Access Compliance Report Public Rights-of-Way (Curb Ramps)

Main Street: FAIRLYNN_BLV Cross Street: ESPERANZA_RD Location: NE

ADA ID: RPAT210923130057 Ramp Type: Type 1 - Perpendicular Diagonal Initial Pass/Fail: Pass Overall Compliance: No Severity Score: 0

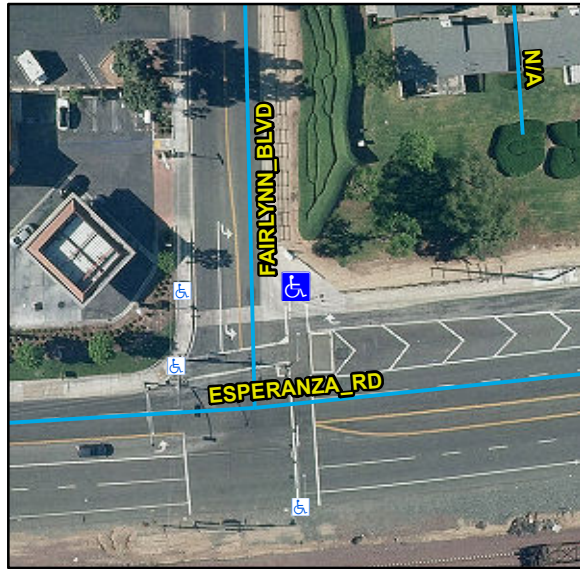
R304.2.2, R304.2.1, R207.1, R304.5.3, STD 1115

Remove & Replace Curb Ramp With Two New Directional Ramps or Equivalent. Restripe Crosswalk. Remove & Replace Gutter.
